Site: *Land At Sodbury Road Wickwar South Gloucestershire GL12 8PG.*

Proposal: Erection of up to 180 dwellings, a local shop and associated infrastructure (Outline) with access to be determined; all other matters reserved.

I have reviewed the archaeological desk-based provided in support of this application, but I have reservations about progressing to approval without further work undertaken.

Figure 1: Hillshade model of 1m DSM LiDAR data showing linear features in the central field. A fainter, but wide, linear is also noted in the southern field.

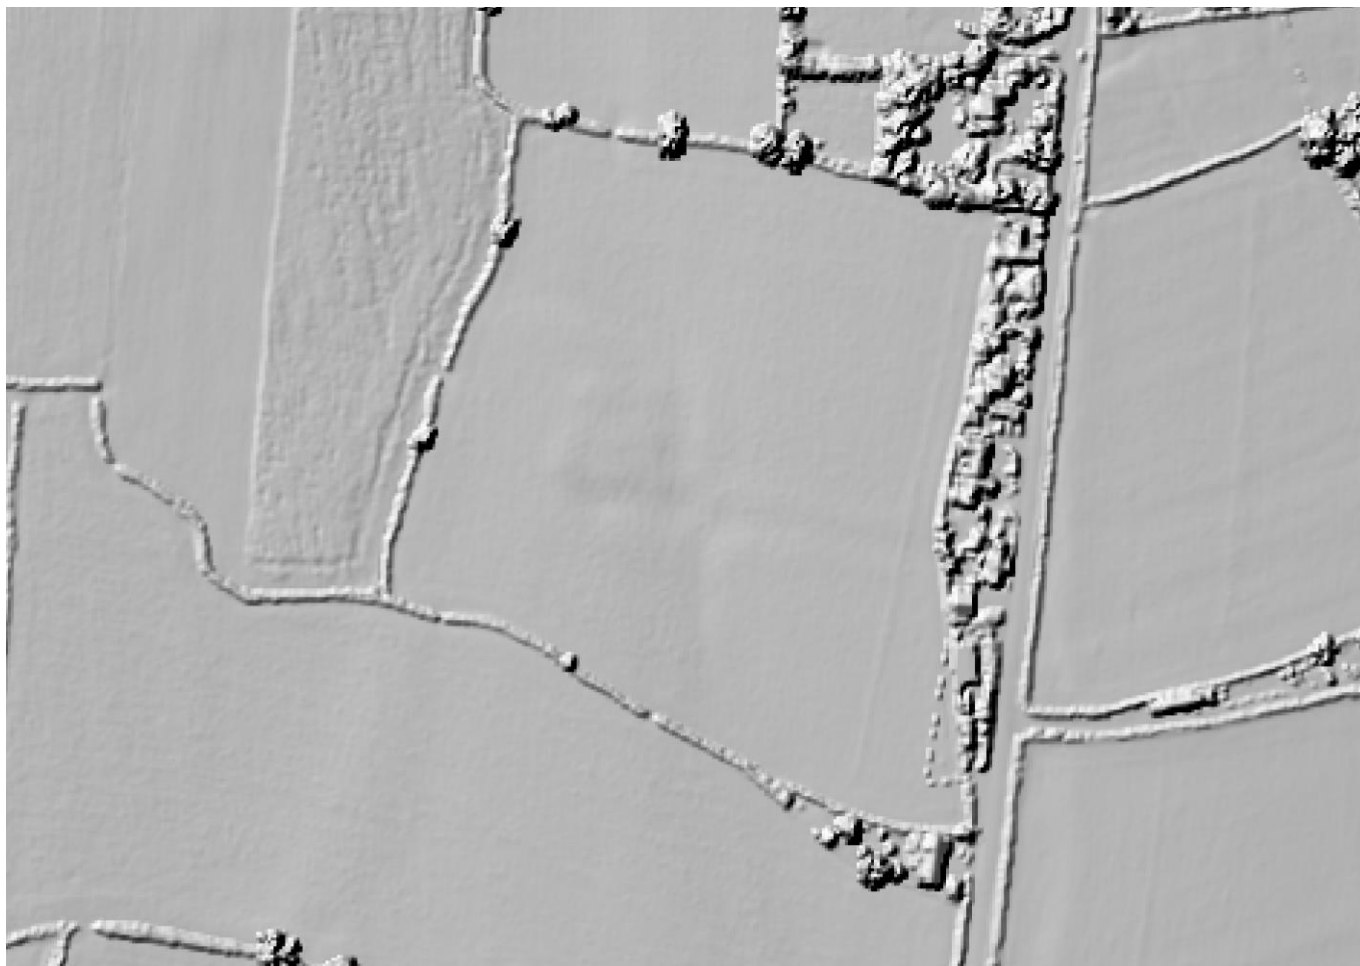
I note that LiDAR was assessed as part of the DBA, but I cannot see any images showing the results of this. The text implies that there was only limited coverage but I have DSM data covering the entirety of the site and upon processing with a simple hillshade model, does show features in the central field as well as possible further feature to the south. Some of these must relate to historic field boundaries as set out in the DBA, but there is a clear eastward linear in the central field that cannot be matched against historic mapping. Admittedly this was only a basic modelling but does highlight potential features on the site.

For the scale of the site, the lack of previous disturbance, the proximity to other known archaeology of varying dates, the possible features identified on LiDAR and in accordance with para 199 of NPPF, I recommend that field evaluation in the form of geophysics be undertaken before the application is determined.
